UNITED STATES PATENT AND TRADEMARK OFFICE

Office Action Summary	Application No. 10/765,030	Applicant(s) PRUITT ET AL.	
	Examiner Alicia M. Torres	Art Unit 3671

DETAILED ACTION

Fig. 10

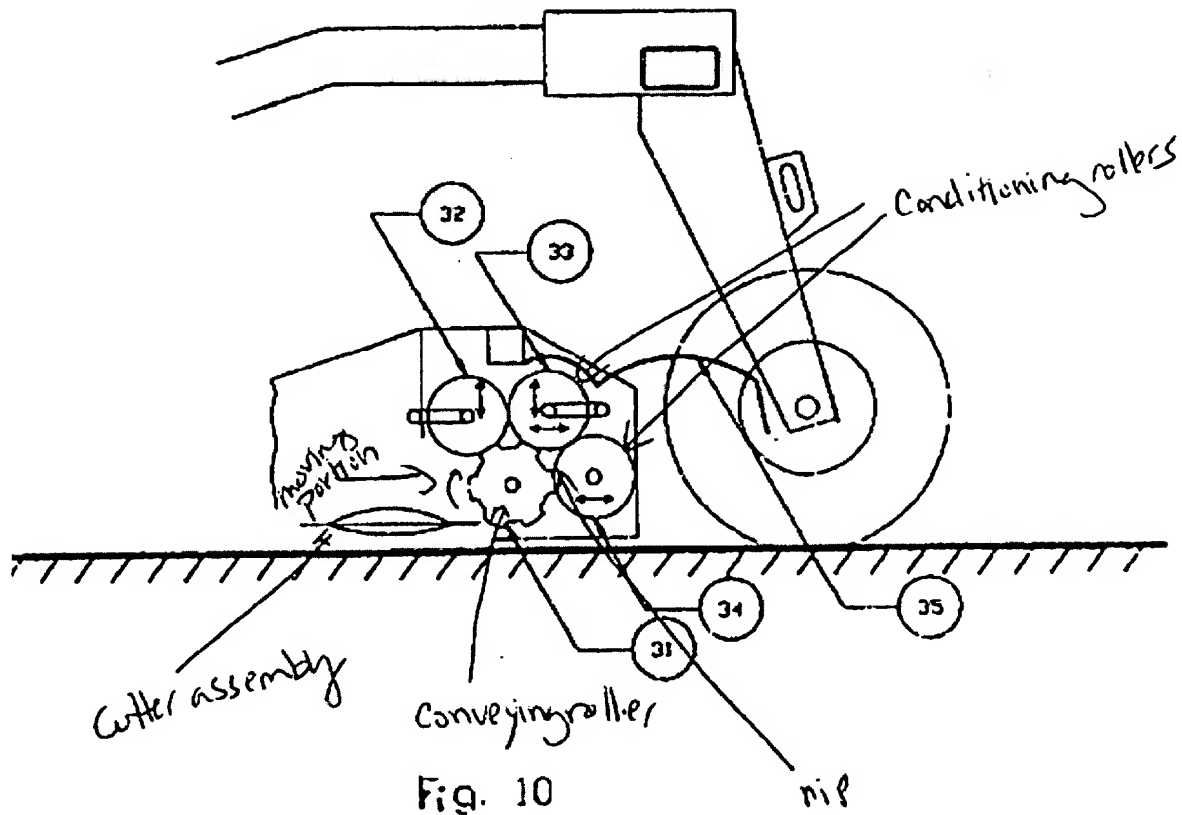
Savoie discloses the claimed device as shown in the marked up figure on the following page. As shown in Fig. 4, the conveying roller has helical ribs, is in the discharge opening and is not wider than the cutters.

However, Savoie fails to disclose wherein the conveying roller has an outermost diameter which is smaller than the outermost diameter of the lower conditioning roll, as per claim 9; and

Wherein a conveying roller axis is generally vertically aligned with the plane of the cutting zone, as per claim 10.
